Title: BRIEFING ON STAFF COMMENTS ON DOE SITE  
CHARACTERIZATION PLAN FOR YUCCA MOUNTAIN

Date: JULY 11, 1989

BRIEFING ON STAFF COMMENTS ON DOE SITE  
CHARACTERIZATION PLAN FOR YUCCA MOUNTAIN

**Figure 1-40.** Faults and fractures at Yucca Mountain interpreted from electrical resistivity data. Stippling shows zone of inferred fracturing and faulting along Drill Hole Wash; fault trends appear to change abruptly across this zone. Modified from USGS (1984).

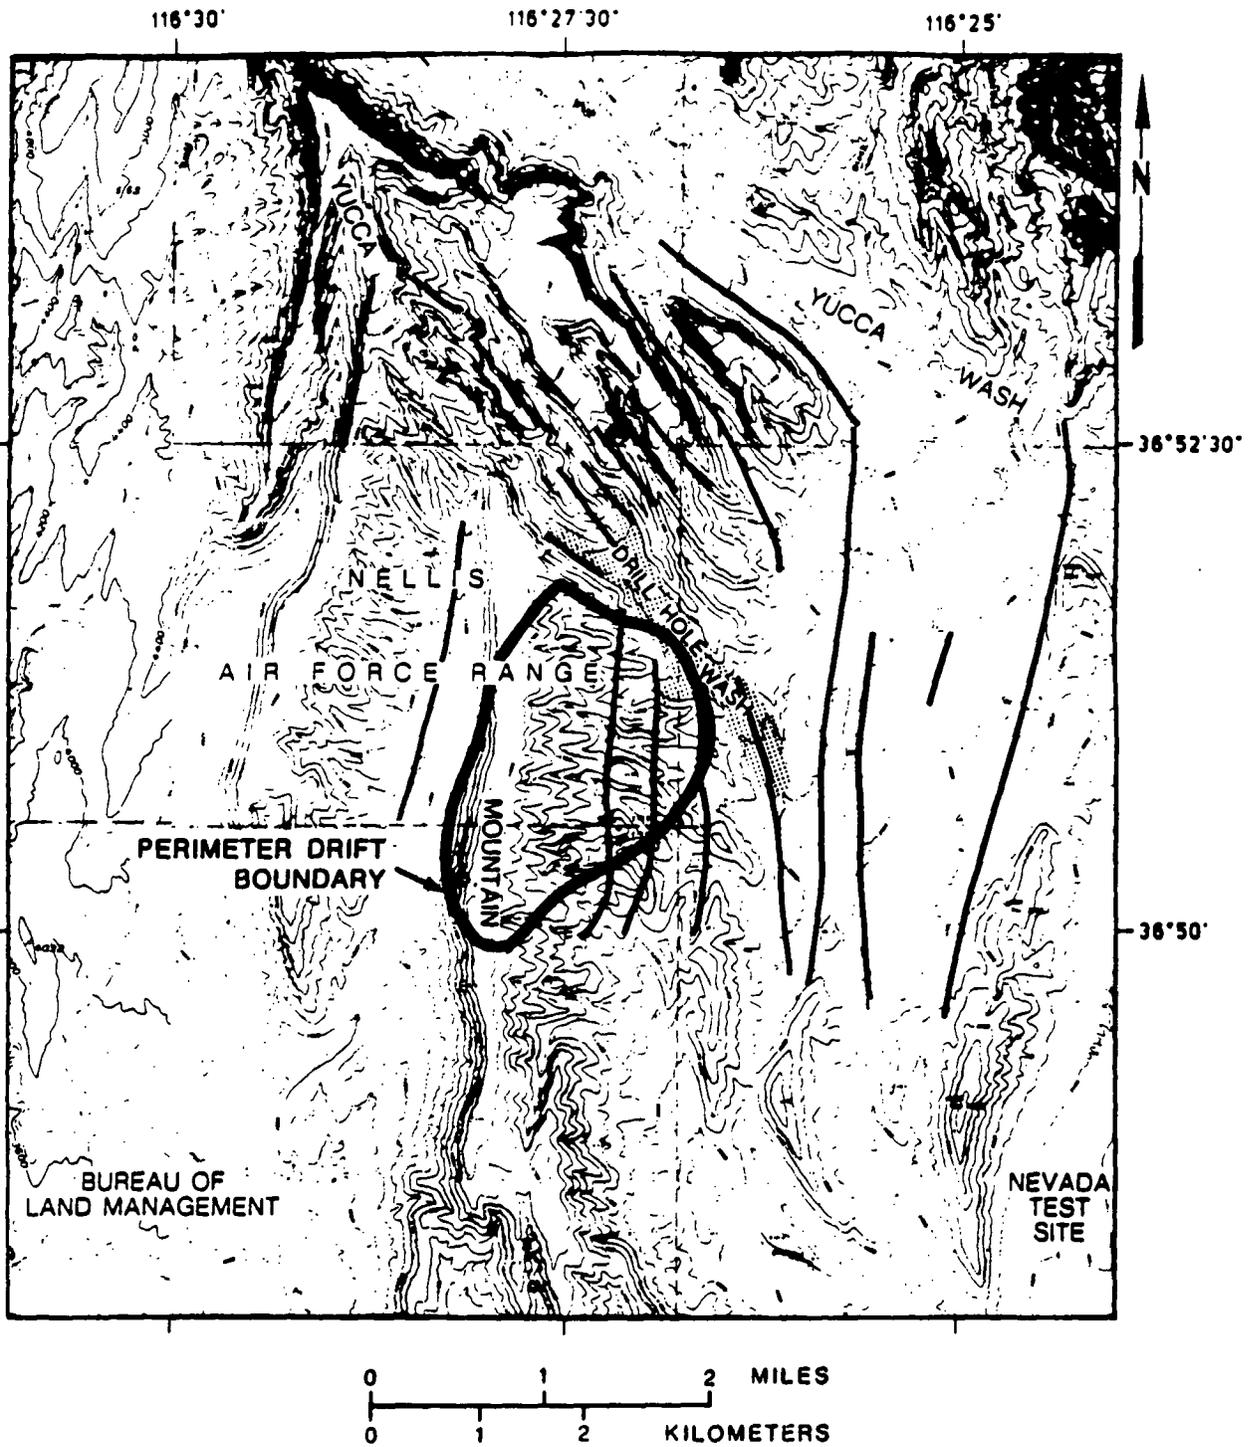
17 Now, they are already working, and the next  
18 figure, page 9, is a map that you may have seen before  
19 from the site characterization plan and from  
20 correspondence related to the case. DOE is already  
21 working at the site on the geologic anomaly or fault.  
22 If you look at the circle -- not a circle but sort of  
23 an ellipse of this site boundary and you see three  
24 vertical lines, the center line is what some people  
25 call the no name fault. It's a geological anomaly.
